## **2007-08 Work Plan Amendments**

**RE: Leviathan Mine, Alpine County, California:  
HDS Treatment System  
Process Design Criteria and Technical Decision Memorandum**

# **Process Design Criteria and Technical Decision Memorandum High Density Sludge Treatment Plant**

**RE: Response to EPA Comments on (i) 2007-08 Treatability Studies and Interim Treatment Activities Work Plan (the “Work Plan”), and (ii) Process Design Criteria and Technical Decision Memorandum for the High Density Sludge Treatment Plant (the “Design Memo”) Leviathan Mine, Alpine County, California**

LEVIATHAN MINE SITE	
DELTA SEEP COLLECTION AREA SCHEMATIC	
PLAN AND DETAIL

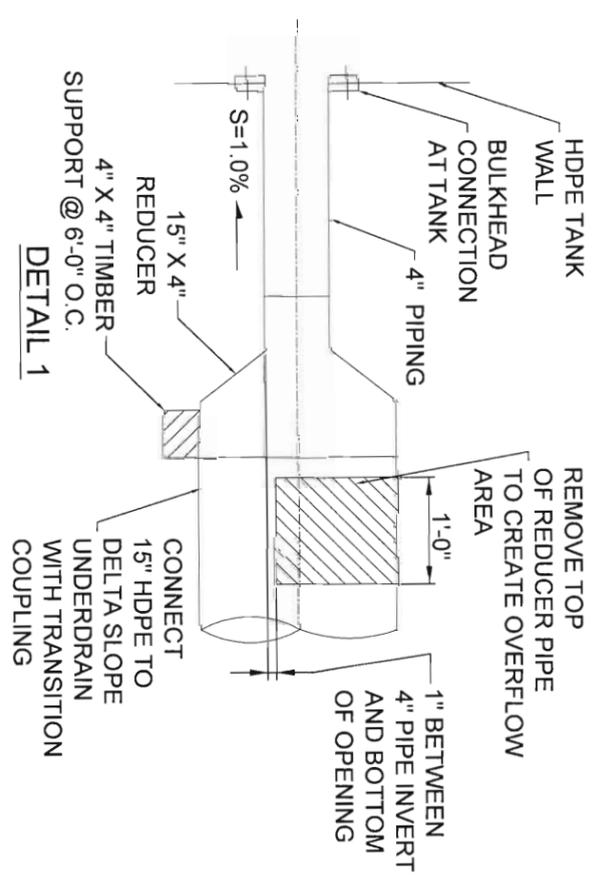
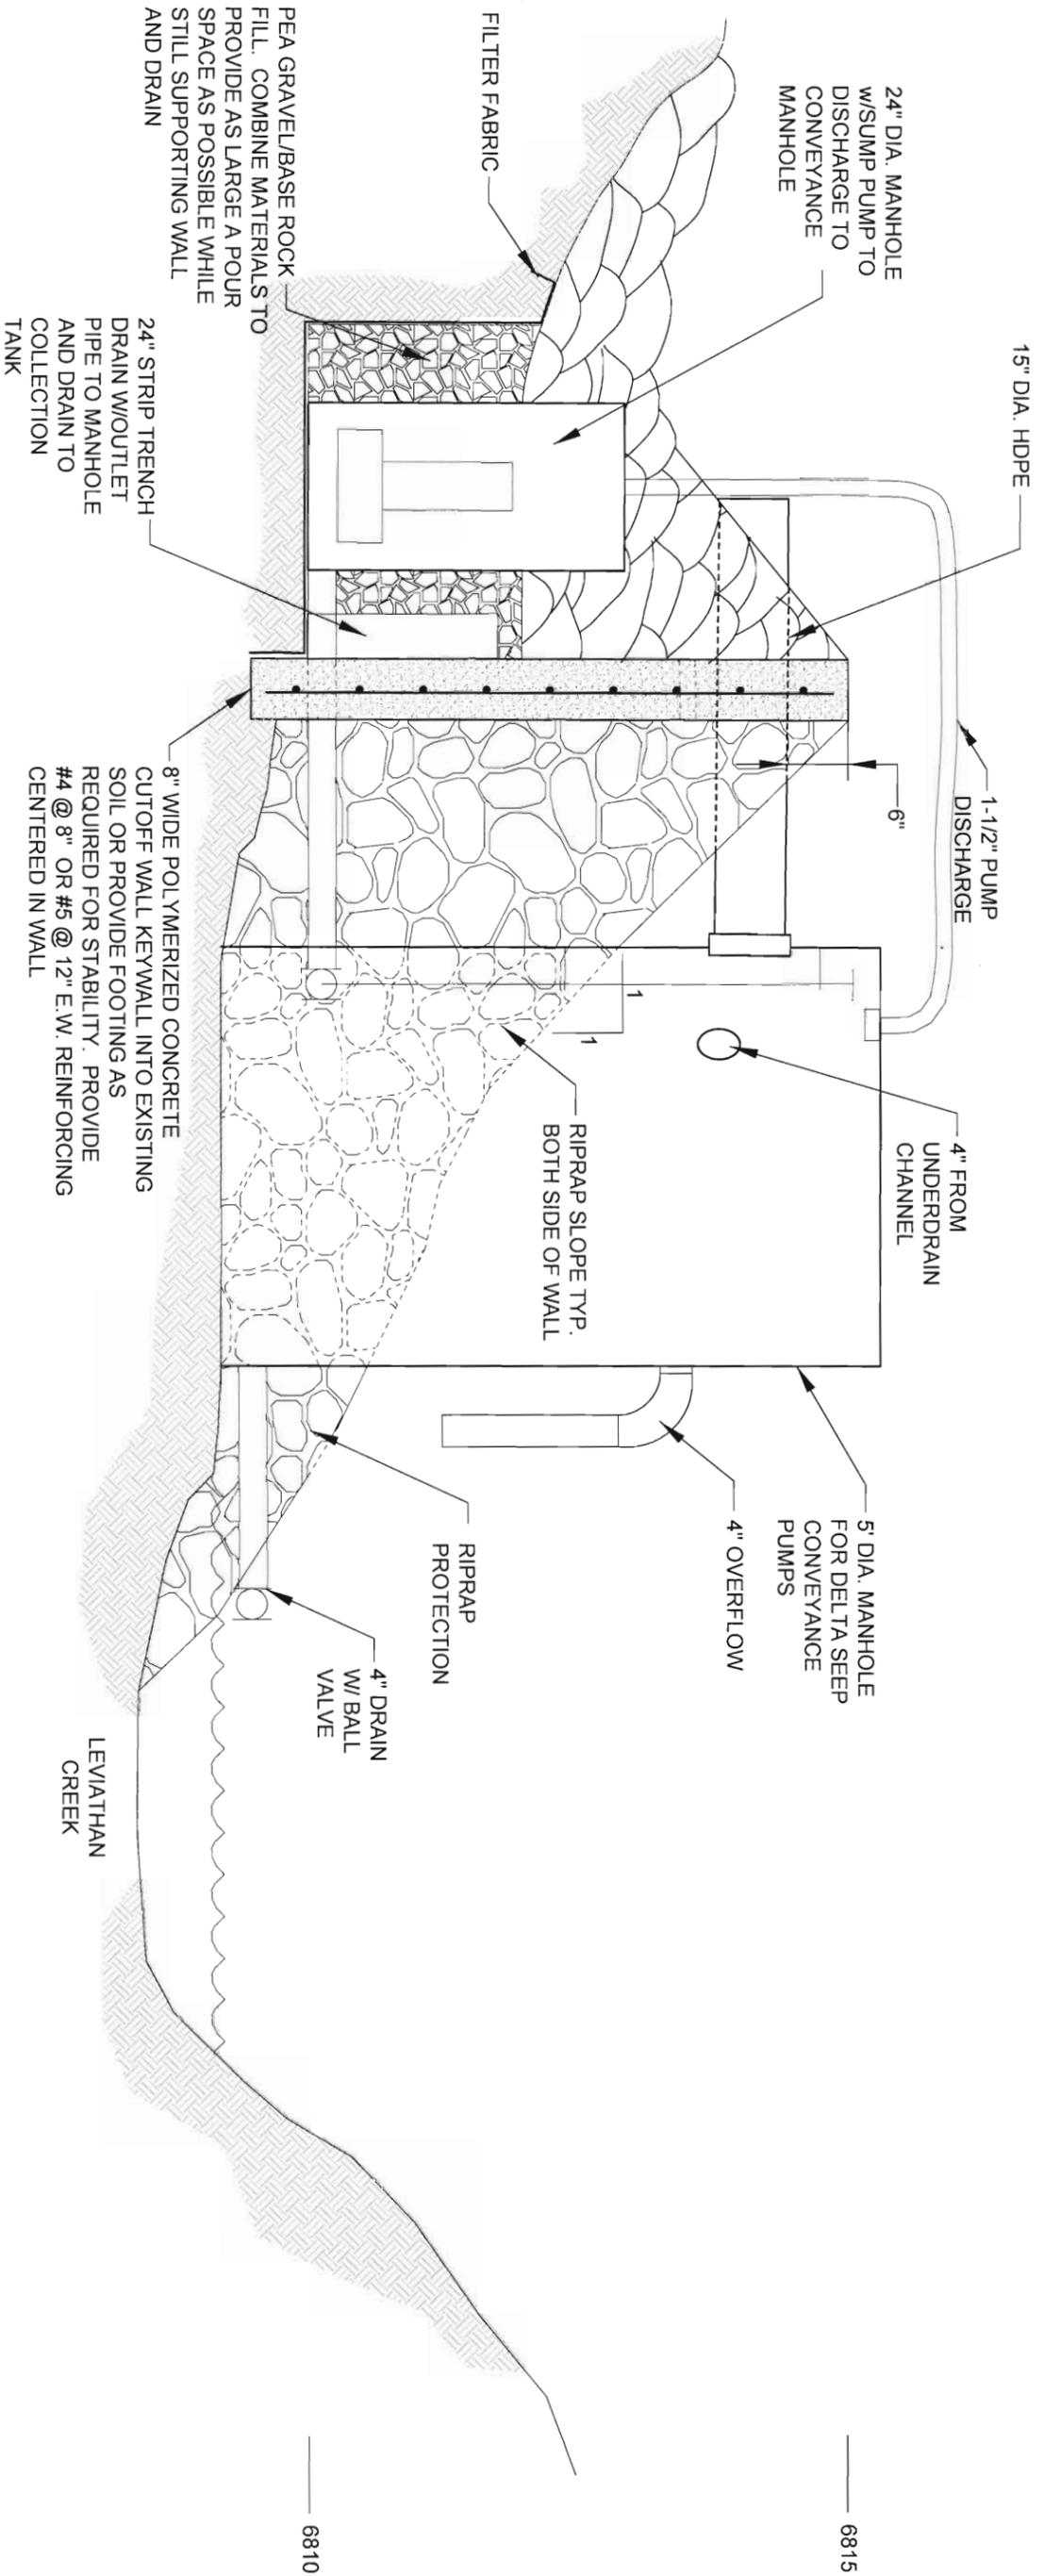
The modified Semi-Permanent Collection System design provides for collection point of both the upper and lower seep areas to evaluate the possibility of collecting the seep flows without relying on mechanical systems. With this revised approach, the cutoff wall will be raised above the upper seep collection point and a 15-inch HDPE collection pipe will be placed through the wall and terminate just upgradient from the wall. This will provide an area for AMD water to collect behind the cutoff wall to a depth of approximately two feet and then the combined seep water would flow into the collection tank through the 15-inch HDPE pipe.

The strip drain, manhole, and sump pump would still be installed and would be used in a backup capacity should the DS flow increase above the capacity of the collection pipe. The sump pump could also be utilized to collect flow should the water level depth behind the cutoff wall not reach the invert of the collection pipe. A 4-inch drain pipe and valve will be added between the strip drain/manhole and the collection tank allow flow to be diverted to the collection tank in the winter months without building up behind the cutoff wall.

The proposed modifications are shown on the attached schematic drawings (Drawings 1 and 2).

Revised Drawings - Delta Seep Collection Area Schematic Drawings 1 and 2
